Access Compliance Report

Public Rights-of-Way

(Curb Ramps)

Intersection ID: N/A	Main Street: ARDREY_KELL_RD	Cross Street: WAVERLY_CENTER_DR	Location: NE
ADA ID: F828EB555440	Ramp Type: Perp	Initial Pass/Fail: Fail	Overall Compliance: No
Severity Score: 12.5			
Codes/Mitigation Info/Possible Solution		Field Measurements/Component Compliance

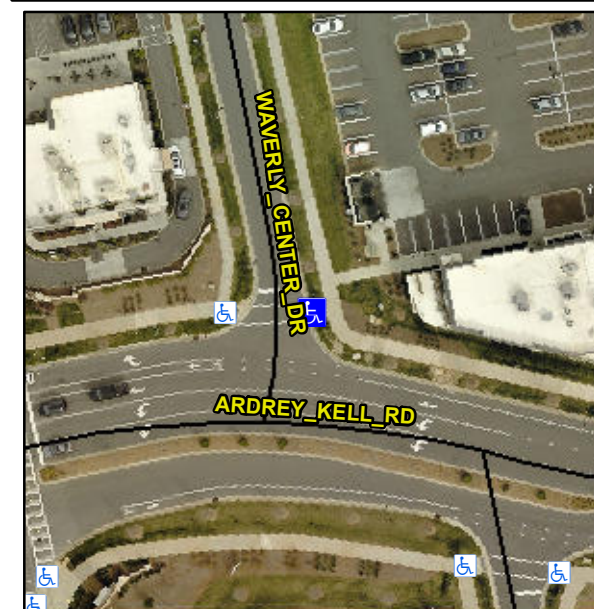
Not Found, R304.2.2

Compliance	Description	Data	Compliance	Description	Data
N/A	Ramp Length (in)	96.0	No	Ramp Slope (%)	9.7
Yes	Ramp Width (in)	95.0	Yes	Ramp XSlope (%)	0.9
N/A	Flare Type LT	N/A	N/A	Flare Type RT	N/A
N/A	Flare Slope LT (%)	N/A	N/A	Flare Slope RT (%)	N/A
N/A	Flare Traversable LT?	N/A	N/A	Flare Traversable RT?	N/A
N/A	Landing Length (in)	N/A	N/A	DWS Provided?	N/A
N/A	Landing Width (in)	N/A	N/A	DWS Contrast?	N/A
N/A	Landing Slope (%)	N/A	N/A	DWS Length (in)	N/A
N/A	Landing X Slope (%)	N/A	N/A	DWS Full Width?	N/A
N/A	Landing Curb? (Y/N)	N/A	N/A	DWS Offset (in)	N/A
N/A	Shared Landing?	N/A			
N/A	Gutter Ponding?	N/A	N/A	Gutter Slope (%)	N/A
N/A	Gutter Lip Ht (in)	N/A	N/A	Gutter X Slope (%)	N/A
N/A	Painted X Walk1?	Yes	N/A	Painted X Walk2?	N/A
	X Walk 1 Direction	To W		X Walk 2 Direction	N/A
N/A	X Walk 1 Width (in)	97.0	N/A	X Walk 2 Width (in)	N/A
	X Walk 1 Slope (%)	2.1		X Walk 2 Slope (%)	N/A
	X Walk 1 X Slope (%)	1.1		X Walk 2 X Slope (%)	N/A

Remove & Replace Entire Ramp.
